SERVICE INFORMATION BULLETIN

SUBJECT: Rear Frame and Stabilizer Bar Bracket

Mounting Bolt- Design Changes

NUMBER: <u>12-296-20R</u>

New Flange Bolt Identification Information:

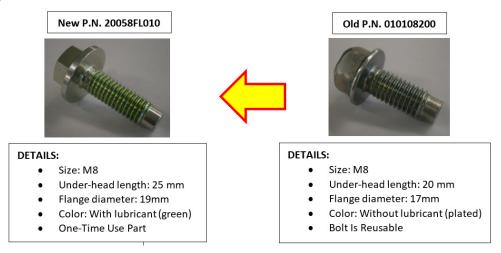
- The new Flange Bolts listed in the table on pg. 1 are **NOT** compatible with weld nuts used in the original frames. **Using the new-style Flange Bolts on the original frames will damage the weld nuts.**
- The original Flange Bolts (p.n. 010108200) are reusable and readily available if needed.
- The new Flange Bolts (p.n. 20058FL010) have a special lubricant applied to their threads and are now One-Time use items.
- There have been no changes to the part numbers of the stabilizer bar brackets.

NEW TORQUE SEQUENCE

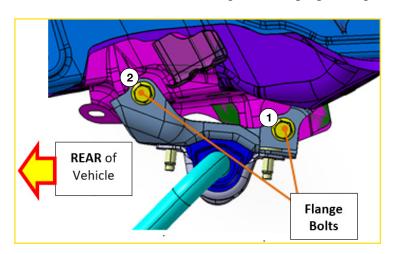
- When reusing the **ORIGINAL** style flange bolts, the torque specification is unchanged (35 Nm / 25.8 ft. lbs.) but, the proper torque sequence supplied below **MUST** be followed. Replacement is not necessary as the original bolts are reusable.
- NEVER reuse the new style flange bolts as they are one-time use items.
- When using the **New-Style** flange bolts, the torque specification is unchanged (35 Nm / 25.8 ft. lbs.) but, the proper torque sequence supplied below **MUST** be followed:

- 1. Temporarily tighten (snug) the front flange bolt (1) then the rear flange bolt (2).
- 2. Torque bolt (1) to 35 Nm / 25.8 ft. lbs. then the rear bolt (2) to the same value.
- 3. Re-check both bolts in the same sequence for proper torque.
